# ADDENDUM

Date:	March 9, 2020
Project:	Mountainstar- Ogden Regional Medical Center <b>Psych Exam Remodel</b> 5475 South 500 East Ogden, Utah 84405
Addendum Number:	<b>1</b>

**PROJECT:** ORMC Psych Exam Remodel

**RE:** Addendum #1

2 PSYCH EXAM REFLECTED CEILING PLAN  
SCALE: 1/4" = 1'-0"

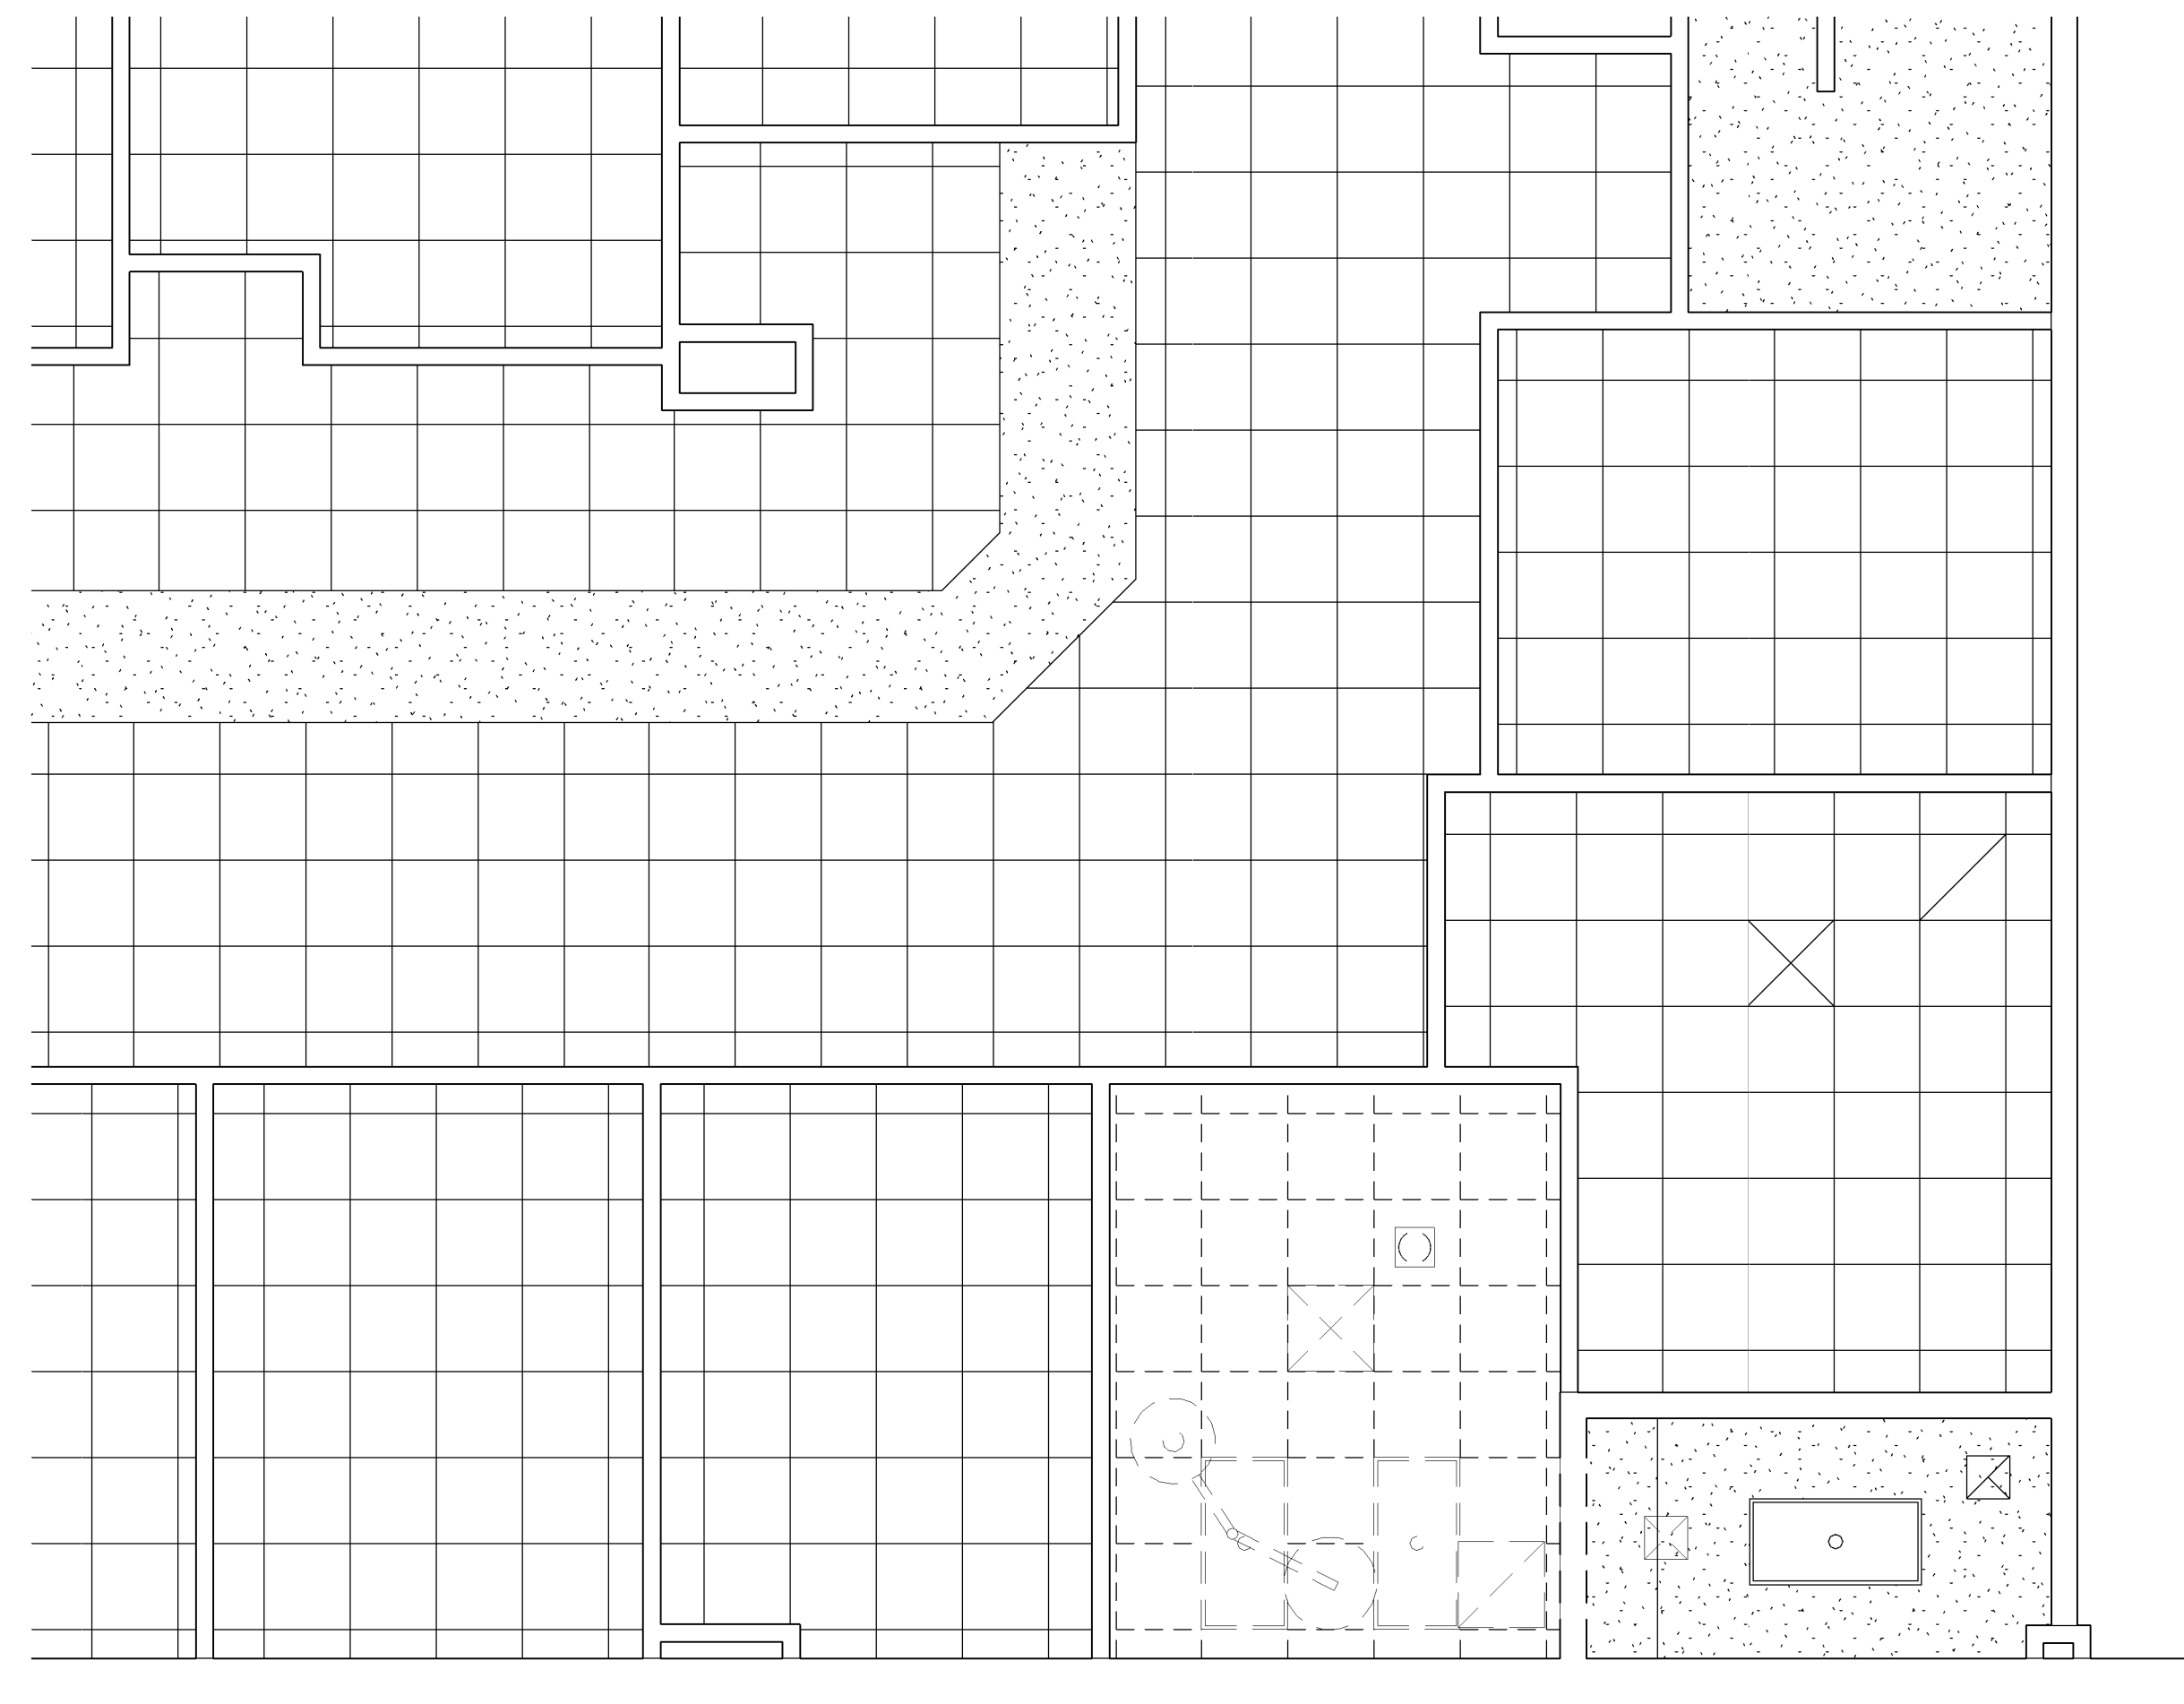
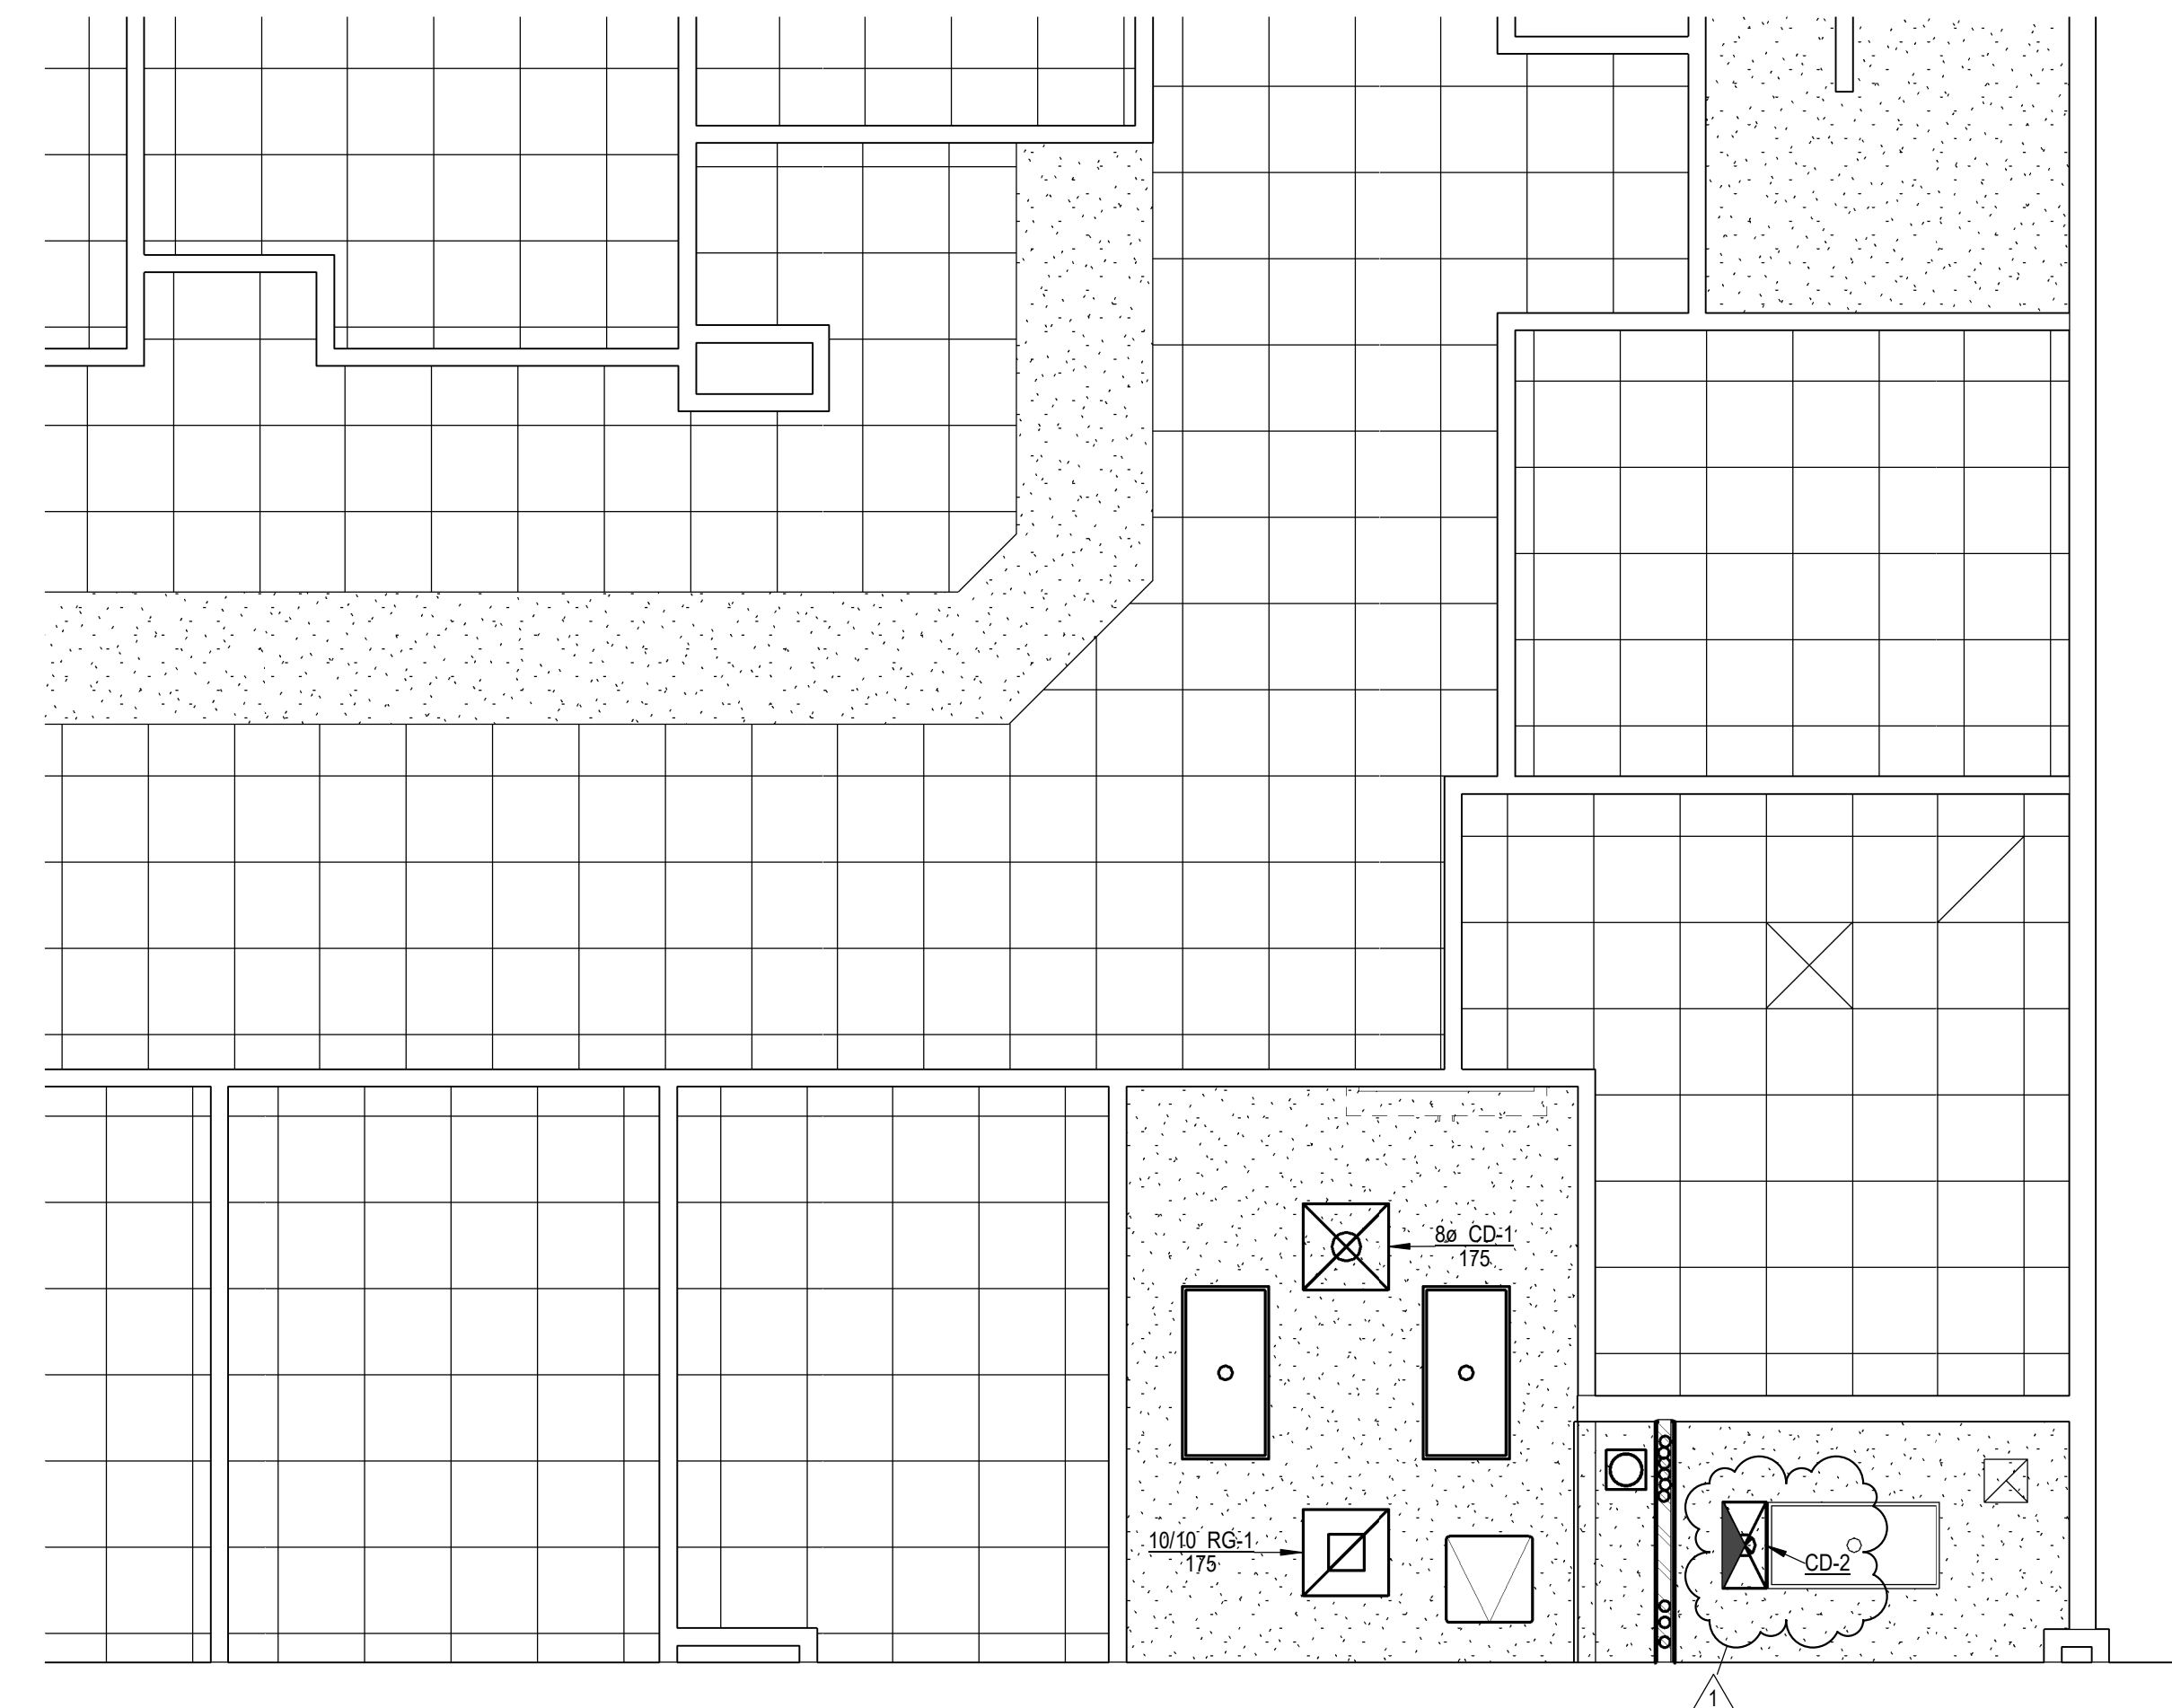
- a. Psych Exam Reflected Ceiling Plan - Patient Toilet A113
    - i. The new CD-2 supply diffuser is now shown in its new location in this room.
3. Sheet MH601 – Mechanical Schedules
